SERVICE BULLETIN

SERVICE BULLETIN		No.: MSB-98E00-503	
		Date: 1998-12-15	<Model> <M/Y>
Subject: CORRECTION TO DIAGNOSIS CODE READING PROCEDURE FOLLOWED WHEN USING WARNING LAMP		(EC,EXP)COLT (CA0A,CC0A) (EC,EXP)	96-10 97-10 97-10
Group: GENERAL		Draft No.: 98AL051414	GALANTE (E50-80) (EC,EXP)L200(K00) (EC,EXP)LANCER (CB0A,CD0A)
CORRECTION	OVERSEAS SERVICE DEPT	 T.NITTA - VICE GENERAL MANAGER QUALITY INFORMATION ANALYSIS

This Service Bulletin informs you of correction to the diagnosis code reading procedure to be followed when using the warning lamp.

Indication of diagnosis code by warning lamp

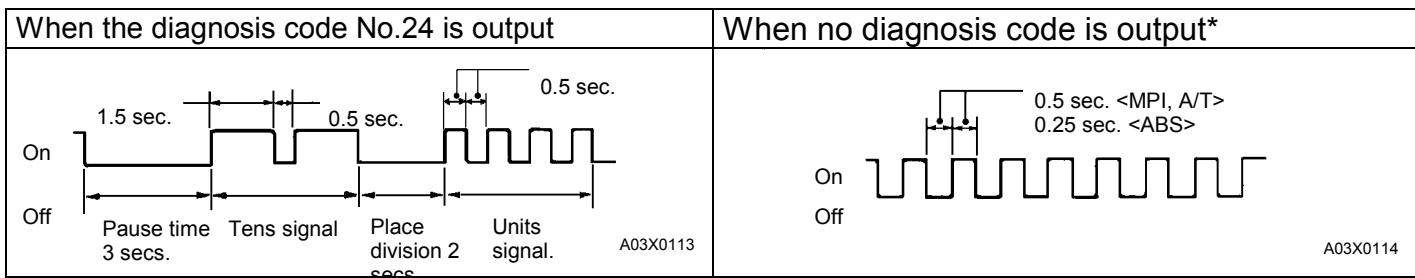
<Incorrect>

3. Turn off the ignition switch.
4. Read out a diagnosis code by observing how the warning lamp flashes.

ON

<Correct>

Indication of diagnosis code by warning lamp

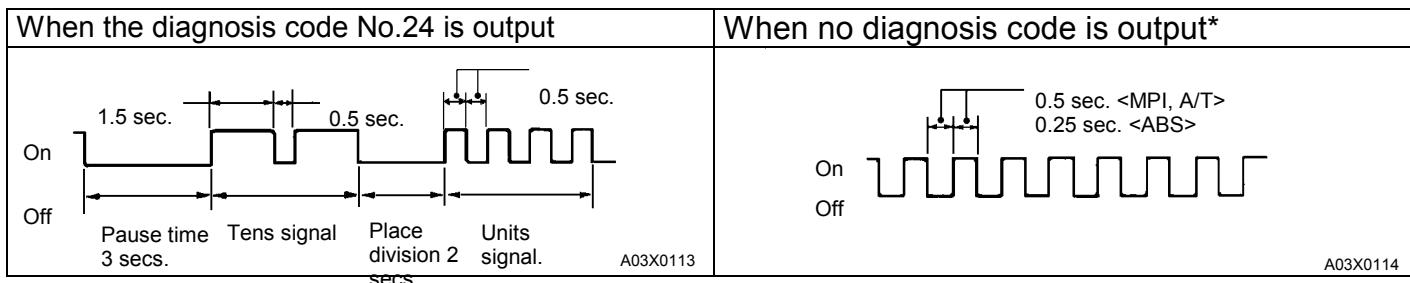
<Incorrect>

3. Turn off the ignition switch.
4. Read out a diagnosis code by observing how the warning lamp flashes.

ON

<Correct>
